Access Compliance Report

Public Rights-of-Way

(Curb Ramps)

Intersection ID: 27236	Main Street: BALLANTYNE CORPORATE PL	Cross Street: BRIXHAM HILL AV	Location: SE
ADA ID: 33C02EE11F92	Ramp Type: Perp	Initial Pass/Fail: Fail	Overall Compliance: No
Severity Score: 25			
Codes/Mitigation Info/Possible Solution		Field Measurements/Component Compliance

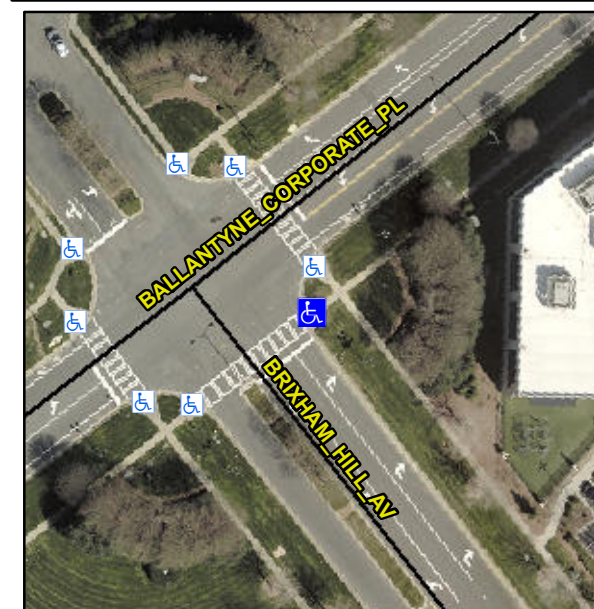
R304.2.2

Compliance	Description	Data	Compliance	Description	Data
N/A	Ramp Length (in)	101.0	No	Ramp Slope (%)	12.9
Yes	Ramp Width (in)	48.0	Yes	Ramp XSlope (%)	0.2
N/A	Flare Type LT	N/A	N/A	Flare Type RT	N/A
N/A	Flare Slope LT (%)	N/A	N/A	Flare Slope RT (%)	N/A
N/A	Flare Traversable LT?	N/A	N/A	Flare Traversable RT?	N/A
N/A	Landing Length (in)	N/A	N/A	DWS Provided?	N/A
N/A	Landing Width (in)	N/A	N/A	DWS Contrast?	N/A
N/A	Landing Slope (%)	N/A	N/A	DWS Length (in)	N/A
N/A	Landing X Slope (%)	N/A	N/A	DWS Full Width?	N/A
N/A	Landing Curb? (Y/N)	N/A	N/A	DWS Offset (in)	N/A
N/A	Shared Landing?	N/A			
N/A	Gutter Ponding?	N/A	N/A	Gutter Slope (%)	N/A
N/A	Gutter Lip Ht (in)	N/A	N/A	Gutter X Slope (%)	N/A
N/A	Painted X Walk1?	Yes	N/A	Painted X Walk2?	N/A
	X Walk 1 Direction	To SW		X Walk 2 Direction	N/A
N/A	X Walk 1 Width (in)	111.0	N/A	X Walk 2 Width (in)	N/A
	X Walk 1 Slope (%)	0.9		X Walk 2 Slope (%)	N/A
	X Walk 1 X Slope (%)	4.6		X Walk 2 X Slope (%)	N/A

Remove & Replace Entire Ramp.
